Nine Mile Point Nuclear Station, Unit 2
Renewed Facility Operating License No. NPF-69
NRC Docket No. 50-410

SUBJECT: Application for Technical Specification Change Regarding Risk-Informed Justification for the Relocation of Specific Surveillance Frequency Requirements to a Licensee Controlled Program (Adoption of TSTF-425, Revision 3)

License Amendment Request

**Application for Technical Specification Change Regarding Risk-
Informed Justification for the Relocation of Specific Surveillance
Frequency Requirements to a Licensee Controlled Program
(Adoption of TSTF-425, Revision 3)**

SR 3.3.4.1.1

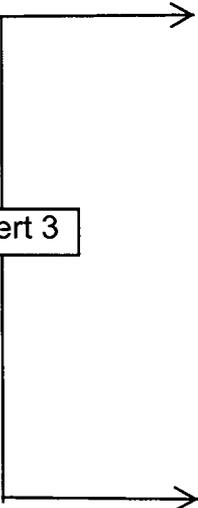
Insert 3

~~The Frequency of 92 days is based on reliability analysis (Ref. 4).~~

SR 3.3.4.2.1

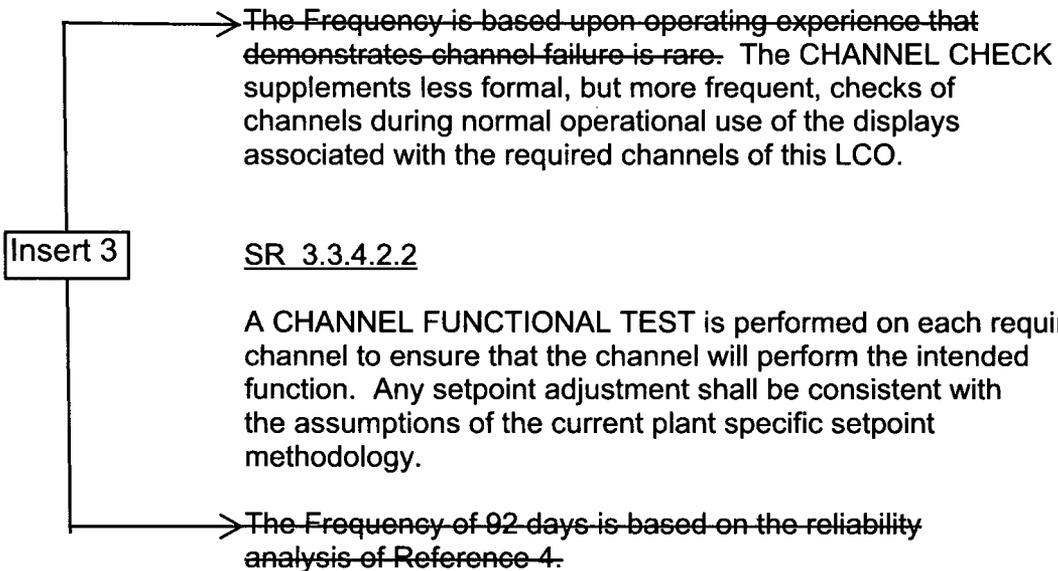
Performance of the CHANNEL CHECK ~~once every 12 hours~~ ensures that gross failure of instrumentation has not occurred. A CHANNEL CHECK is normally a comparison of the parameter indicated on one channel to a similar parameter on other channels. It is based on the assumption that instrument channels monitoring the same parameter should read approximately the same value. Significant deviations between the instrument channels could be an indication of excessive instrument drift in one of the channels or something even more serious. A CHANNEL CHECK will detect gross channel failure; thus, it is key to verifying that the instrumentation continues to operate properly between each CHANNEL CALIBRATION.

~~The Frequency is based upon operating experience that demonstrates channel failure is rare. The CHANNEL CHECK supplements less formal, but more frequent, checks of channels during normal operational use of the displays associated with the required channels of this LCO.~~

SR 3.3.6.1.4 (continued)

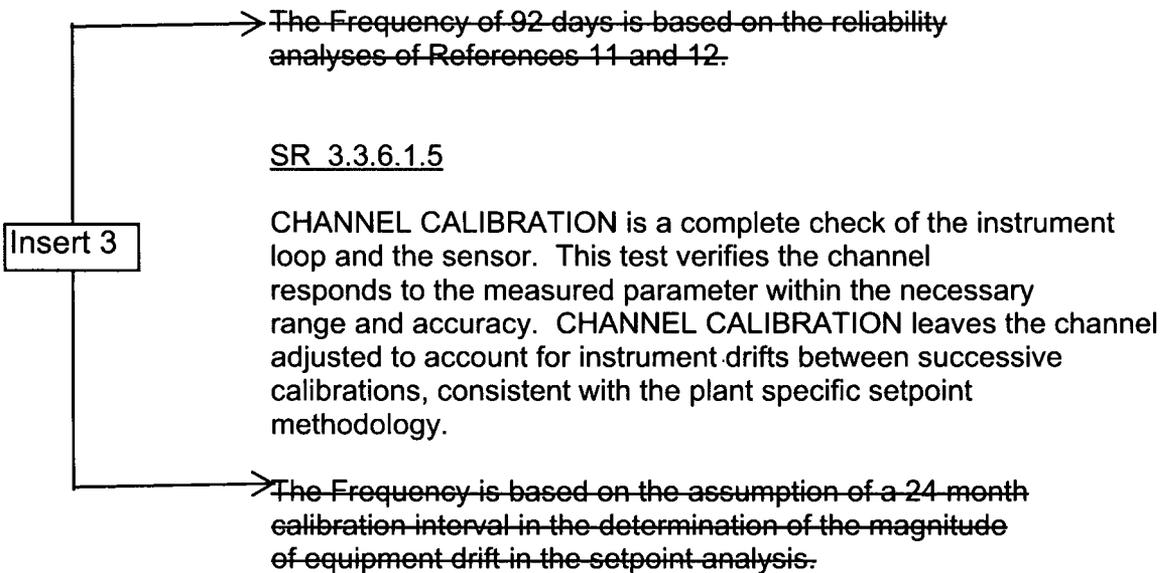
~~The Frequency of 92 days is based on the reliability analyses of References 11 and 12.~~

~~SR 3.3.8.2.3~~

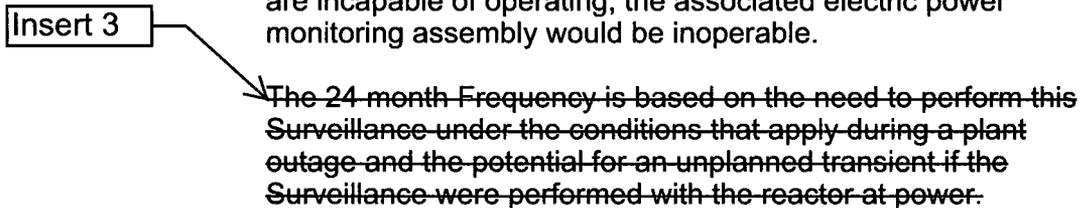
~~The 24 month Frequency is based on the need to perform this Surveillance under the conditions that apply during a plant outage and the potential for an unplanned transient if the Surveillance were performed with the reactor at power.~~
